POLICY REPORT  
DEVELOPMENT AND BUILDING

Report Date: September 7, 2010  
Contact: Grant Miller  
Contact No.: 604.873.7484  
RTS No.: 08802  
VanRIMS No.: 08-2000-20  
Meeting Date: September 21, 2010

TO: Vancouver City Council  
FROM: Director of Planning  
SUBJECT: CD-1 Rezoning of 605-645 West 41st Avenue

**PARKING**

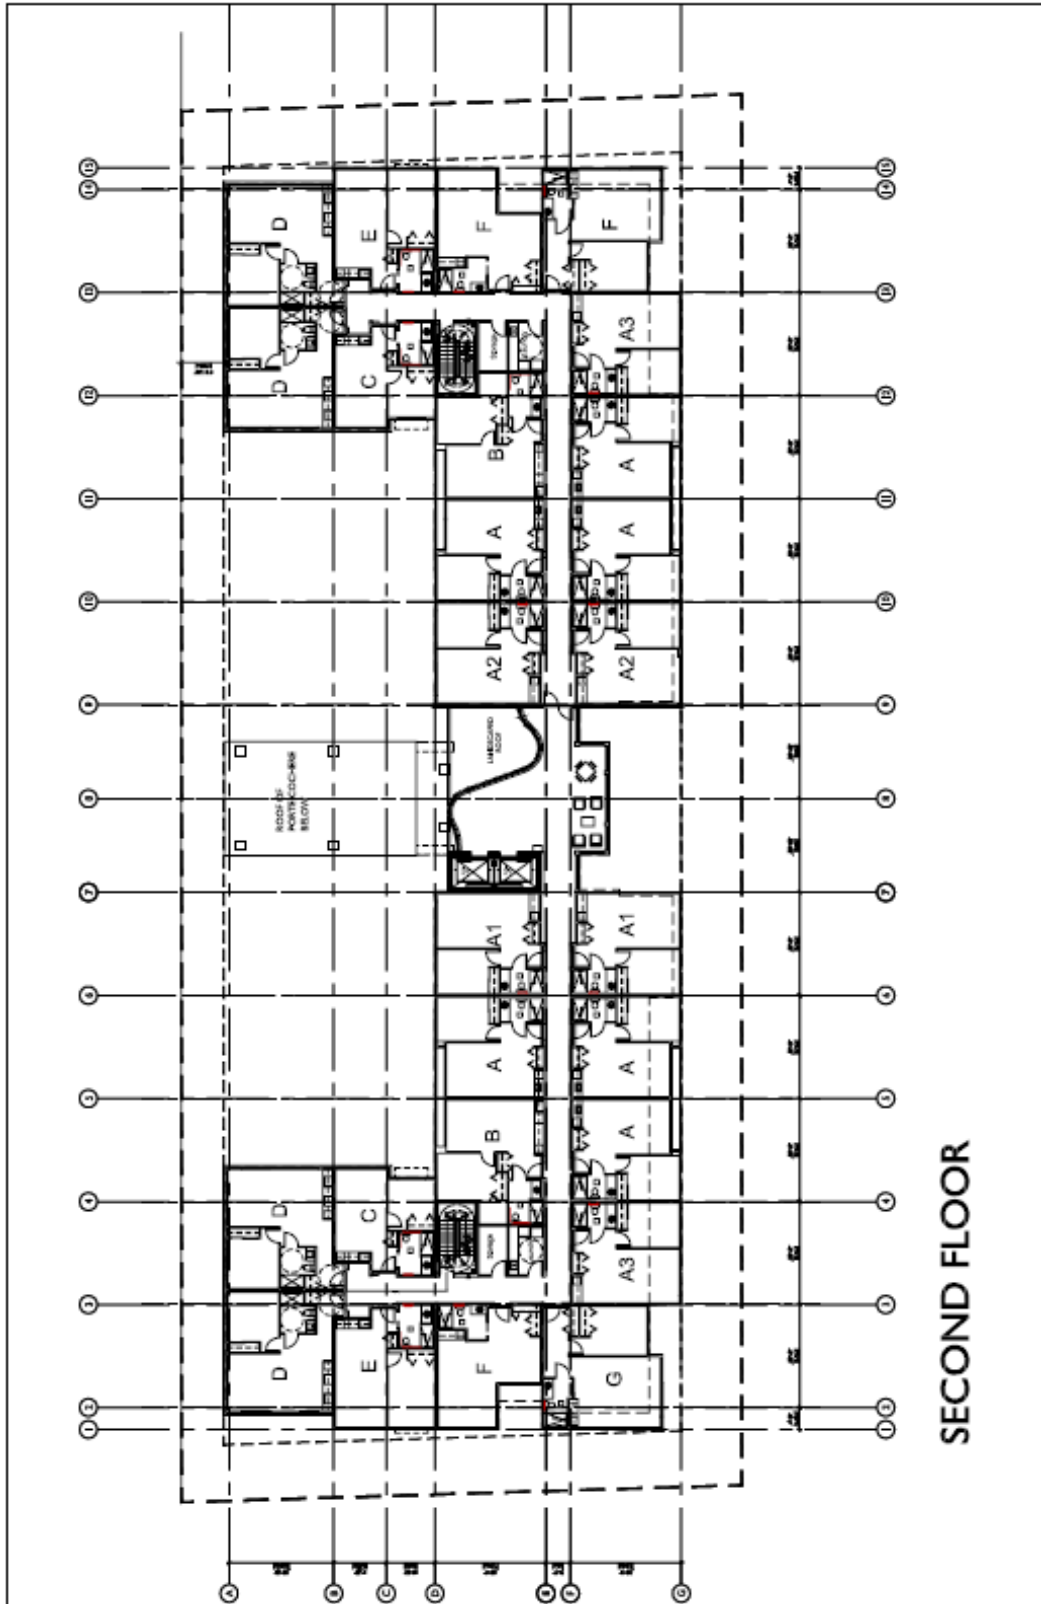
23. Provision of an improved plan showing the design elevations within the loading bay clearly showing slopes and crossfalls;

24. Excessive slope on the inside curve of the parking ramp;

Note to Applicant: the inside curve has a slope of 17.6% from elevations shown, not 15% as indicated.

25. Provision of a 9'x9' corner cut to improve the two-way flow and visibility on the main ramp;

26. Provision of a section drawing showing elevations, vertical clearances, and security gates for the main ramp and through the loading bay;

27. Modify driveway design at gridline B10 to provide a straight curb rather than a curved bulge;

Note to Applicant: this would make it easier for drop off vehicles to access the underground parking spaces. Please ensure the 22 ft. width is maintained.

28. Number all parking spaces;

29. Remove parallel parking space at gridline G8 from the plan;

Note to applicant: this space cannot be counted as a parking space due to the adjacent column restricting access in and out of the stall.

30. Provision of measures to improve visibility of oncoming traffic for parking spaces between gridlines E6 and E9;

Note to applicant: the curve in the drive aisle, especially for the disability spaces and the small car space restricts visibility and parabolic mirrors are recommended.

31. Provision of additional stall width for all parking spaces with columns located more than 4 ft. (1.2 m) from the end of the stall;

SOUTH ELEVATION

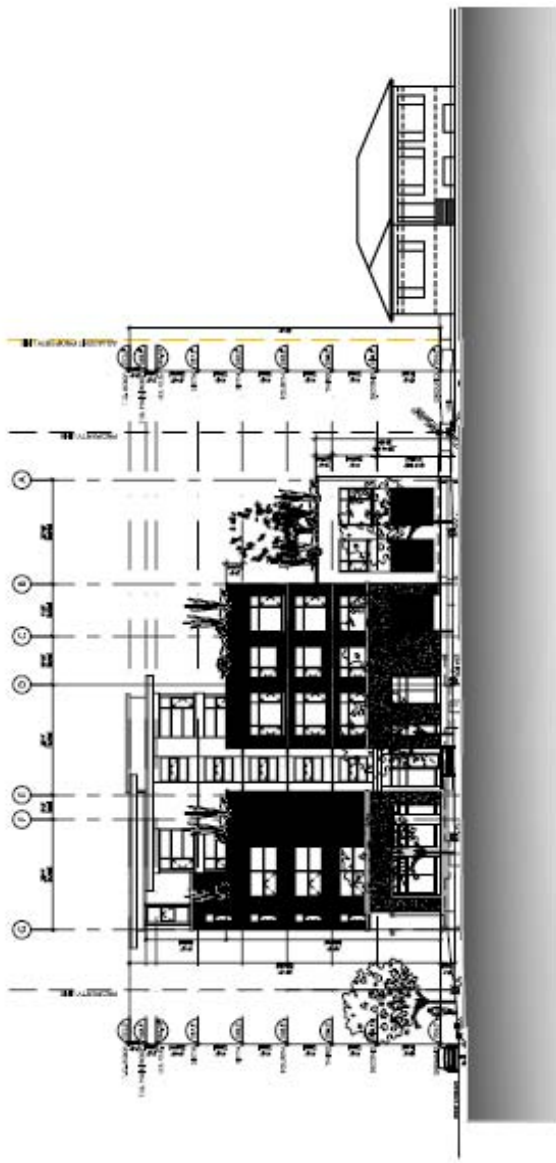
5. provision of sun shades or other solar control features to reduce solar gain and develop the expression of the south wall including the central glazed bay;
6. notation on the elevation drawings of all finishes, materials, dimensions and colours;
